ToAll Lamborghini Dealers and Licensed Service PointFromCustomer Service DepartmentSubjectThrottle body Ecu replacementGroup714.9.71Date25.07.08Pages6

Throttle body Ecu replacement (ETB).

Gallardo Model Year 08 (Coupè, Spyder and Superleggera) VIN-Range: from 8LA04825 to 8LA07525.

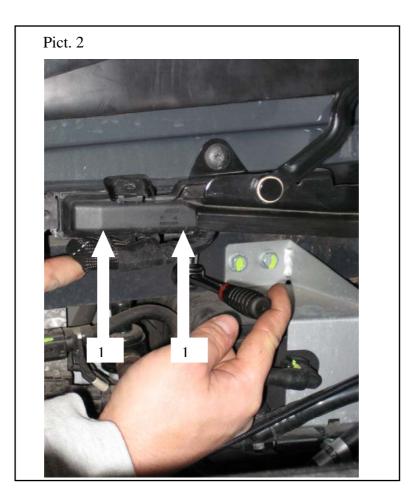
- **1.1** Open the rear bonnet using the handle placed behind the driver seat.
- **1.2** Remove the 5 bolts (1-Pict.1) and the black cover (2-Pict.1).

1.5 Replace the ETB ecu with the new one (p/n 400906018B). Re connect the cable of ETB ecu (1-Pict.3), reassemble the ETB ecu (tightening torque 9 Nm) and the black cover (2-Pict.1) (tightening torque 5 Nm).

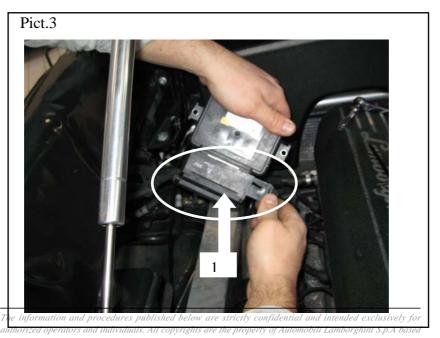
1.3 Remove the 2 bolts (1-Pict.2) of the ETB ecu.

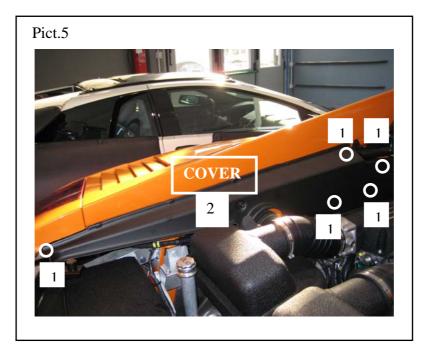
- 2.1 Open the rear bonnet using the handle placed behind the driver seat.
- **2.2** Remove the 5 bolts (1-Pict.5)

- **2.3** Disconnect momentarily the hydraulic piston (1-Pict.6) that holds the engine bonnet in the up position (workshop manual istruction 082703). When disconnecting the hydraulic piston from the engine bonnet be careful the bonnet can fall down. Please have an external support on the engine bonnet during this operation.
- **2.4** Remove the cover (2-Pict.5).

2.6 Remove and replace the ETB ecu (p/n 400906018B) as explained at the points 1.3 and 1.5. Disconnect again the hydraulic engine bonnet (1-Pict.6) as explained at point 2.5. Reassemble the black cover (2-Pict.5) and the hydraulic engine bonnet (1-Pict.6) (workshop manual instruction 082705).
